### **Paling Yards Wind Farm – Environmental Impact Statement (SSD-29064077)**

### Paling Yards Wind Farm – Environmental Impact Statement

## BCS detailed comments

Figure 1 – Figure 12 in the EIS shows two sub-stations in the north-east corner (highlighted in blue) while Figure 1.1 of the BDAR only includes one sub-station (highlighted in yellow).

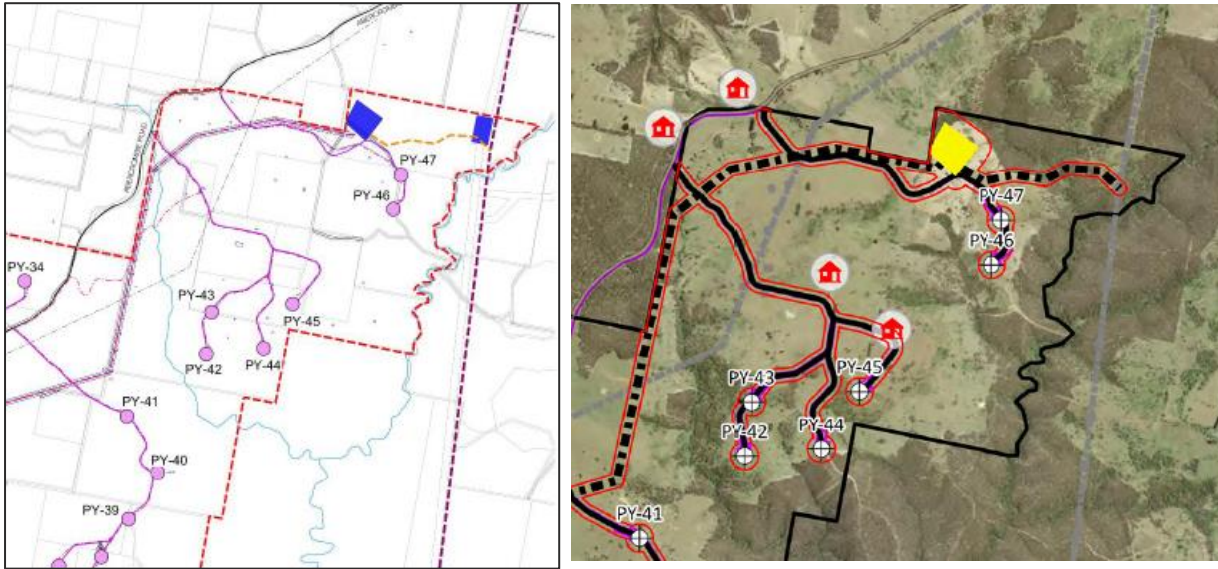
The indicative site layout provided in Figure 12 of the EIS is also inconsistent with the project layout displayed in Figure 1.1 of the BDAR. One sub-station has not been assessed in the BDAR and associated spatial package (Figure 1). If the sub-station has been excised from the footprint, the EIS should be revised to show the current development footprint.

Furthermore, limited information has been provided about the layout of the electrical cable network in the EIS and the BDAR. We note that trenched electrical reticulation within access tracks can be difficult to achieve without significantly impeding construction schedules. The trenching required for electrical cables may not be able to be accessed by construction machinery without diverting outside of the development footprint. We recommend that the cable network is reviewed to ensure that the maximum amount of access track clearing required for construction has been captured within the BDAR.

- 2.1 Clarify whether all components of the development that will impact on biodiversity values, including ancillary and temporary facilities, have been included in the development corridor and subsequent biodiversity credit calculations.

Figure 3 – A section of Abercrombie Rd adjacent to the site boundary has been included in the development footprint (emphasised in pink). No survey assessment has occurred for this section of road, and no detail on any potential impacts or upgrades has been included in the BDAR.

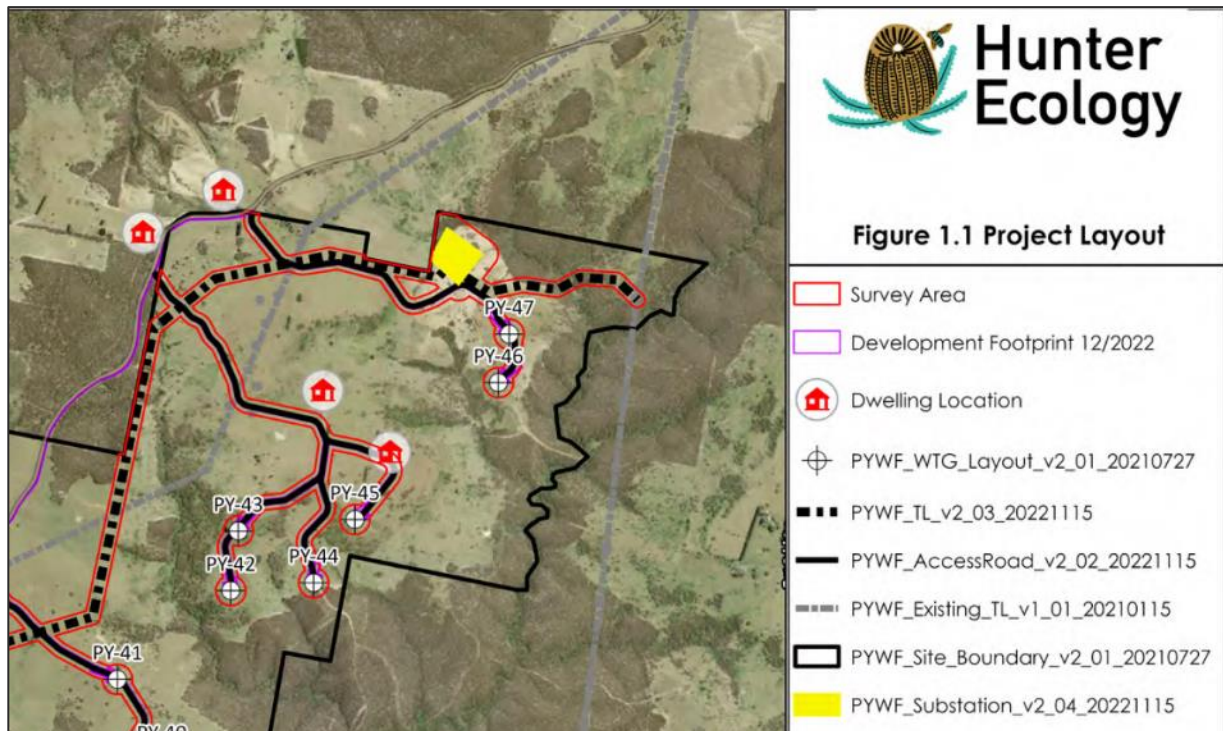
Further information on potential biodiversity impacts to Abercrombie Road should also be provided. A section of Abercrombie Road adjacent to the site boundary has been included in the development footprint, however no information has been provided on any potential upgrades to this section of road (Figure 3). BCS notes that no fauna or flora surveys have been conducted in this portion of the development footprint.

If road upgrades impacting on biodiversity values are required to facilitate the project, this should be detailed in the BDAR and BAM-C case. If the road has been included in the development footprint erroneously, this should be rectified in the BDAR and EIS.

- 3.1 Assess the biodiversity impacts of transport road upgrades, and include any impacts to biodiversity values in Section 1.3 of the BDAR and the subsequent biodiversity credit calculations.
- 3.2 Review the potential biodiversity impacts to Abercrombie Road adjacent to the project site. If the road has been included in the development footprint erroneously, revise the project layout mapping in the EIS and BDAR.

Figure 4 – Examples of areas that appear to contain native vegetation within the development footprint, that have not been included in the native vegetation mapping.

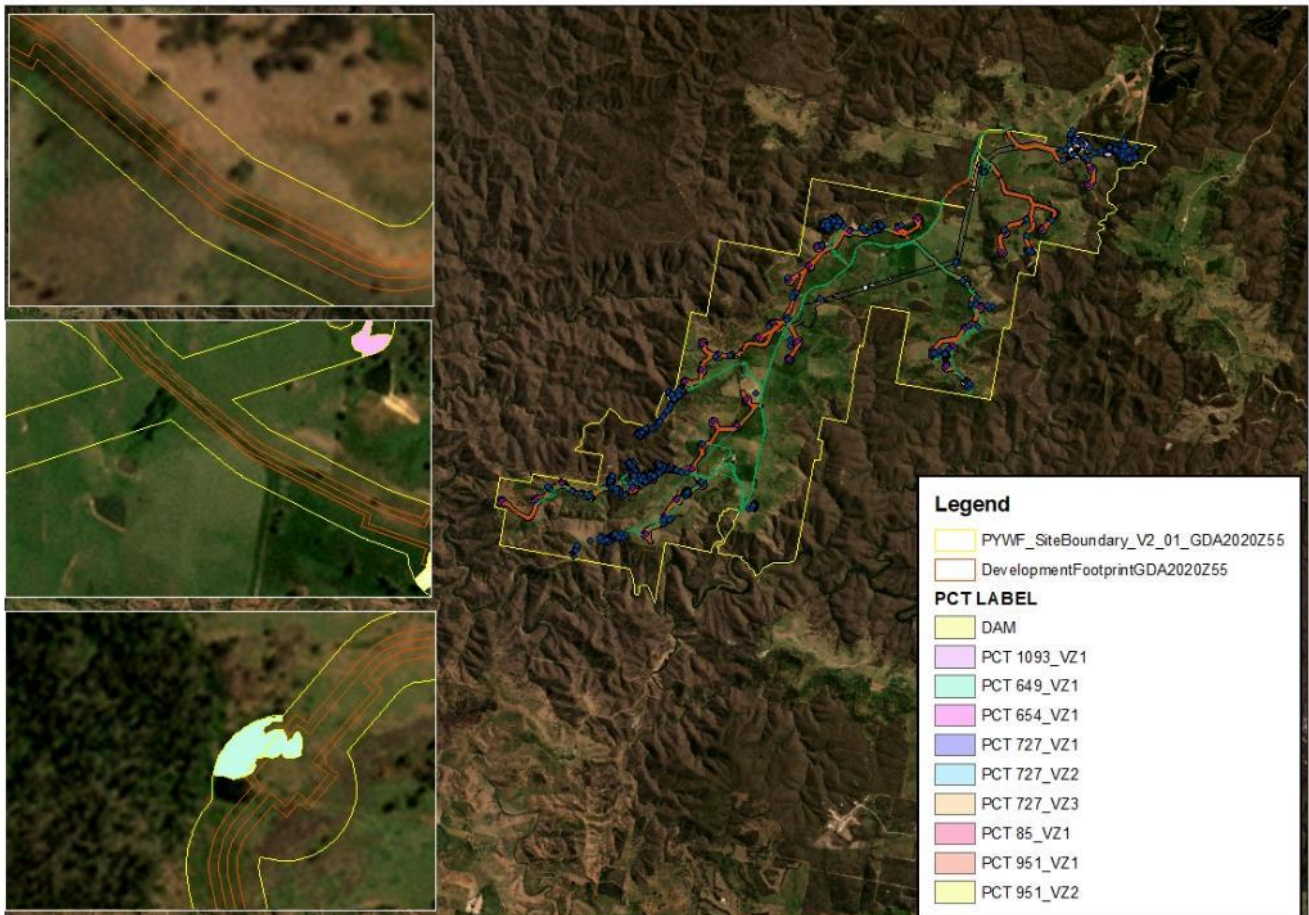
We have reviewed the spatial data provided and note that there are several areas that appear to contain native vegetation that have not been included in the native vegetation mapping, nor assigned to a PCT. Examples of native vegetation that has not been included in the vegetation mapping are provided at Figure 4 below.

The native vegetation extent mapping should include all native vegetation including scattered trees and native ground cover. If the vegetation is planted or exotic, this should be clearly stated in the BDAR and delineated in the vegetation mapping.

- 4.1 Revise the native vegetation extent mapping for the project to comply with a linear-based assessment method in accordance with section 3.1.2 of the BAM
  - 4.2 Revise the BAM-C case if the updated vegetation mapping changes the vegetation cover class for the project.
- 
5. The native vegetation extent mapping is inconsistent with aerial imagery and requires review.

Figure 5 – Large areas of the development footprint have been mapped as exotic vegetation. No BAM plots or rapid vegetation assessments have occurred in these areas.

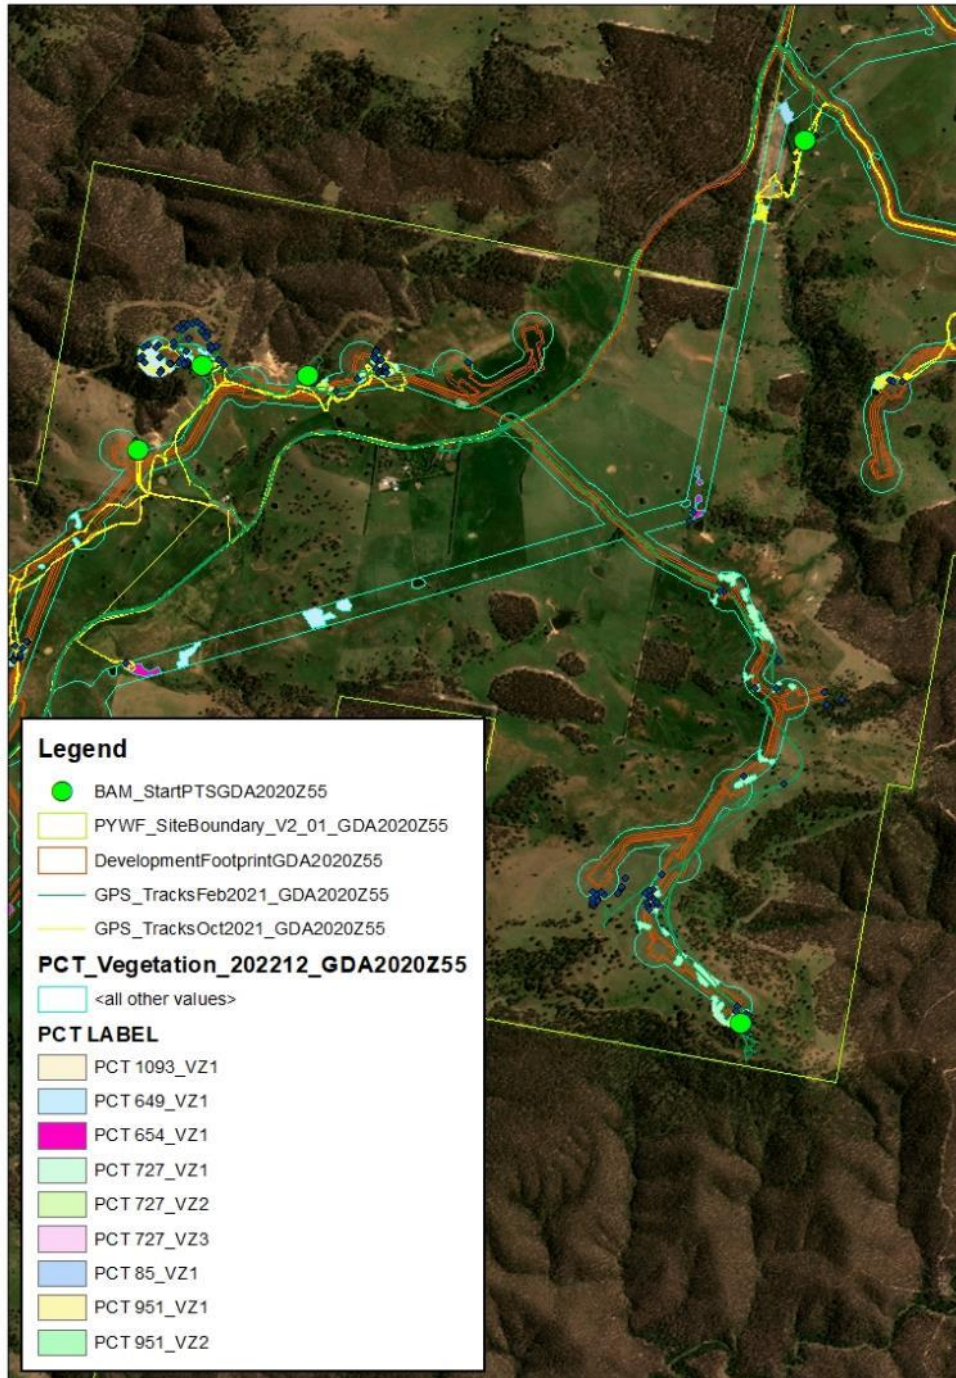
There are several areas that have been mapped as exotic vegetation throughout the project site. As areas of non-native vegetation do not require assessment under the BAM, they should be clearly justified in the BDAR. While Section 3.5 of the BDAR states that cleared grassland was overwhelmingly dominated by exotic species, it is not stated whether these grasslands were assessed through BAM plots, rapid vegetation assessments of another survey method.

Furthermore, we note that no surveys or vegetation integrity assessments were undertaken in the central portion of the transmission line easement (Figure 5). This is of particularly relevance for grassland vegetation in proximity to PCT 654 vegetation zones which are associated with Box Gum Woodland Critically Endangered Ecological Community (CEEC).

Figure 6 – Survey effort for the proposed Paling Yards Wind Farm. The ‘GPS\_Tracks’ logs do not contain any information about which species were targeted, or the conditions in which the surveys were conducted.

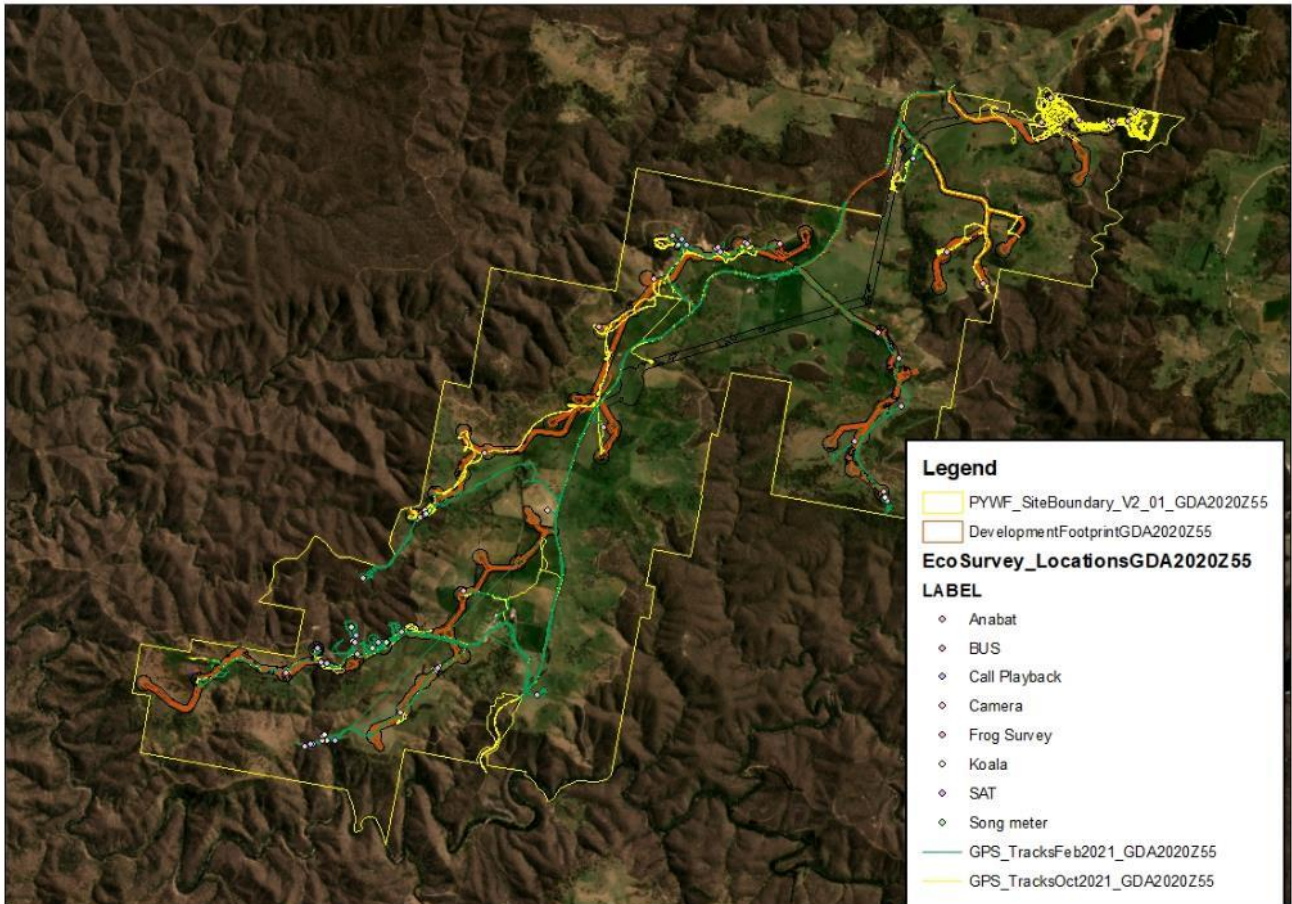
From our review of the spatial data and the BDAR, we are unable to determine the level of survey effort that has been applied for several candidate species within the buffered development footprint. The spatial data and Figure 4-2 of the BDAR identify several point locations for survey techniques such as call playback and camera trapping, but no information is provided on any survey transects (Figure 6).

From a review of the spatial data, it is difficult to distinguish between grid point searches, potential pedestrian traverses and traverses potentially undertaken via vehicle whilst driving between search locations. It is unclear which species were targeted during the track surveys, where each species was surveyed and what conditions the surveys occurred under (i.e. diurnal or nocturnal surveys).

Data should be provided for each candidate species, including but not limited to digital shape files of all survey locations, transects and vegetation grids, as per Appendix K of the BAM.

- 12.1 Provide digital shape files that clearly demonstrate the survey effort applied for each candidate species credit species within the buffered development footprint.
- 12.2 Revise Figure 4-2 in the BDAR to include figures that clearly demarcate the survey effort applied for each candidate species credit species in accordance with Appendix K of the BAM.

Figure 8 – Microbat survey effort across the proposed Paling Yards Wind Farm

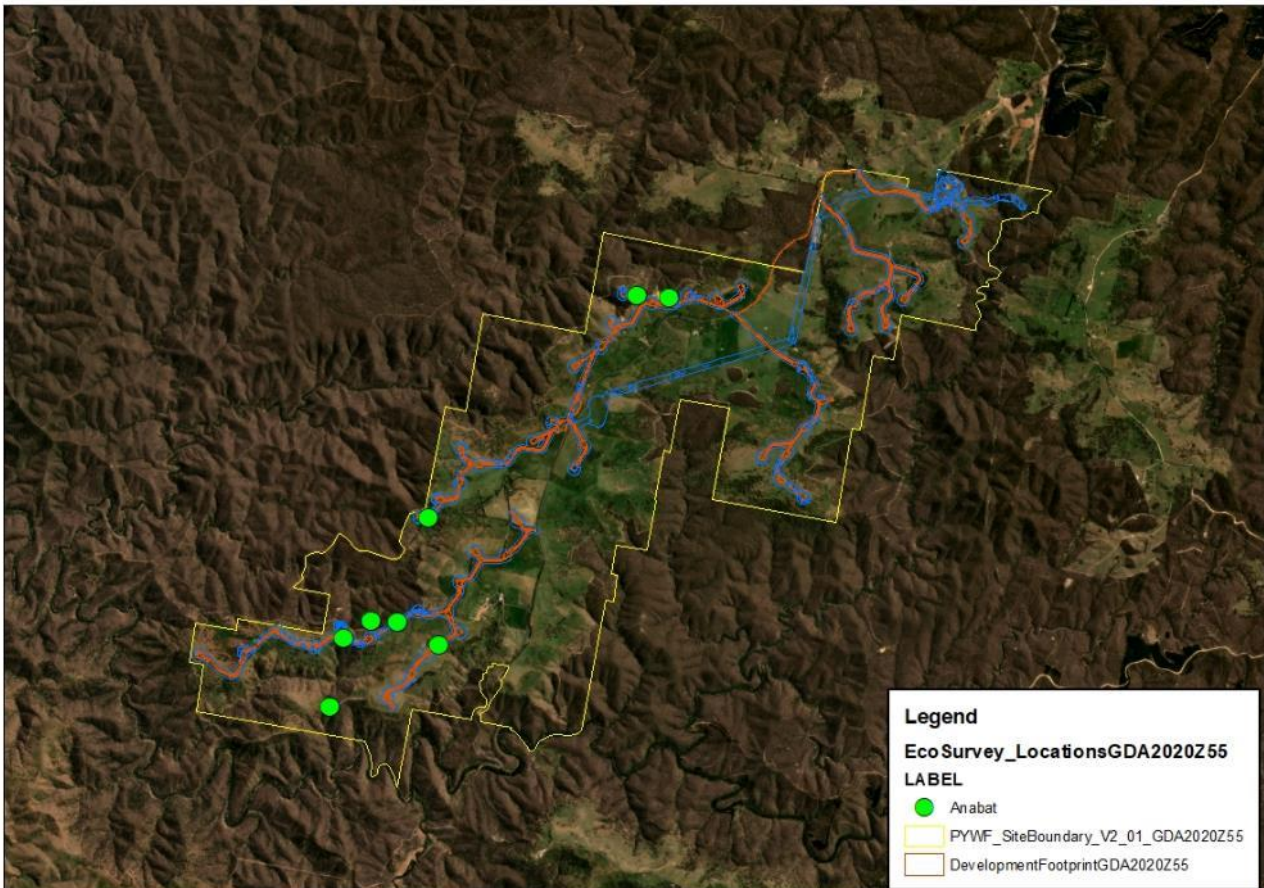
We note that the variation in deployment duration or the limitations of the different anabat models has not been justified. Furthermore, the lack of survey effort across the proposed development (Figure 8) has not been discussed. Section 3.1.4 of Appendix E of the BDAR states:

Given the limitations of the devices used, the inconsistency in survey methods and the lack of survey coverage across the development footprint, we consider that the bat utilisation surveys for the site could not address indirect impacts to microbats.

In addition, all bat detectors were placed near ground level and no bat call data was recorded at-height from detectors set on wind masts. The bat utilisation assessment does not include any information on species flying at rotor swept height, where strike impacts are likely to occur. This limitation was acknowledged in section 3.1.4 of Appendix E in the BDAR, but no survey occurred to further assess microbats likely to be impacted by turbine strike or barotrauma.
